# Vera C. Rubin Observatory

## Image Capture Simplification

Kian-Tat Lim

# Proposed Removal of DM Capture

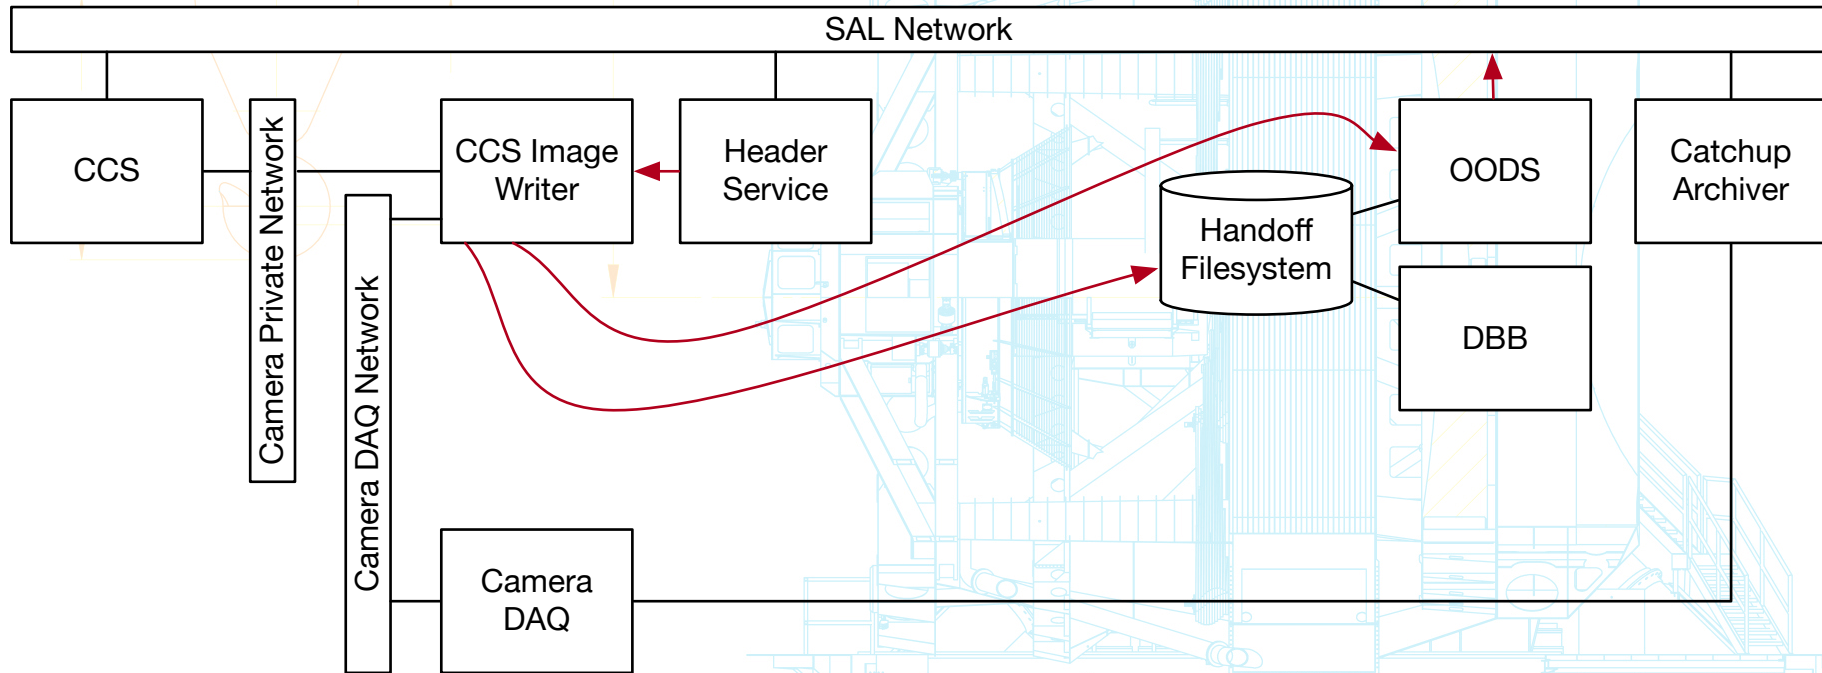
- Reduced code maintenance
- No need for DAQ client over DWDM
- No possibility of Archiver being disabled/down when image is taken
- Single source of image truth
- Engineering images captured the same way as science/calibration

## Necessary Additions, in priority order

1. Header Service/LFA interface
2. Copy to "handoff" for OODS/DBB and to Prompt Processing
3. Possibly trigger OODS and Prompt Processing
4. Telemetry and events
5. Fault tolerance and hot spares
